Subject: Oconee Nuclear Station
Docket Numbers 50-269, 270, and 287
Supplement 2 to License Amendment Request
associated with the Passive Low Pressure
Injection Cross Connect Modification
Technical Specification Change (TSC) Number
2003-02

Attachment
RAI-12 Response Related to Oconee Amendment Request

Figure 1. Comparison of Leakage Size Cracks for Various Crack Morphology Parameters

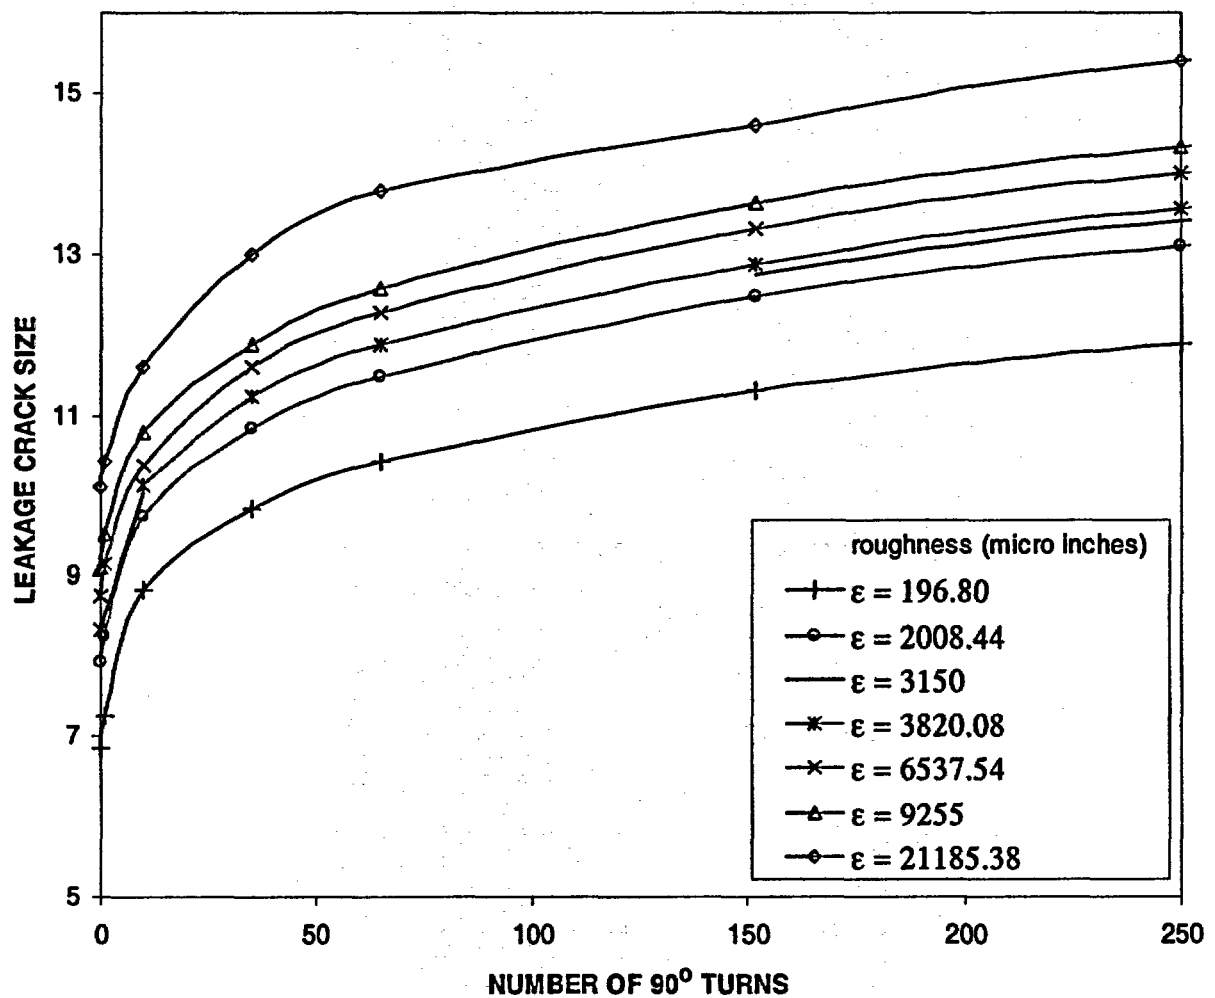
RAI-12: Due to the recent V.C. Summer event of primary water stress corrosion cracking (PWSCC), the staff has a general concern over PWSCC and other unidentified degradation mechanisms on proposed LBB piping. As a result, the staff requested recent LBB applicants to perform a sensitivity study using a crack morphology (surface roughness and number of turns) characteristic of transgranular stress corrosion crack (TGSCC). Information contained in NRC NUREG/CR-6443, "Deterministic and Probabilistic Evaluations for Uncertainty in Pipe Fracture Parameters in Leak-Before-Break and In-Service Flaw Evaluations," may be useful. You only need to perform this analysis for SMAW weld at location 2 having a margin of 2.4 on flaw sizes. The staff understands that using the suggested TGSCC crack morphology will reduce the margin significantly. The purpose is to know how much margin (10 for leakage, and 2 for flaw sizes) that the piping still has should a TGSCC occur.

57 tests (utilizing FANP's program KRAKFLOW) were run using combinations of the surface roughness and number of turn values in Table 1. It was decided to maintain the margin of 10 on leakage. The resulting leakage size crack lengths and margin on flaw size were determined for the various permutations of crack morphology. Table 2 lists the leakage size cracks and Table 3 lists the corresponding margins on flaw size. Figures 1 shows the leakage size crack lengths vs. number of 90° turns, while Figure 2 shows the margin on flaw size vs. number of 90° turns.

The leakage size cracks in Table 2 all have a margin on leakage of 10. For the NUREG/CR-6443 highest default crack morphology parameters for surface roughness of 3150 μin and largest default number of 90° turns of 152/in, the margin on flaw size is 1.527. Using the range of surface roughness and number of turns specified above, it was not possible to obtain a margin less than 1.104. The parameters that would be required to obtain a margin of 1.0 or less are considered highly unlikely, even for a TGSCC type crack.
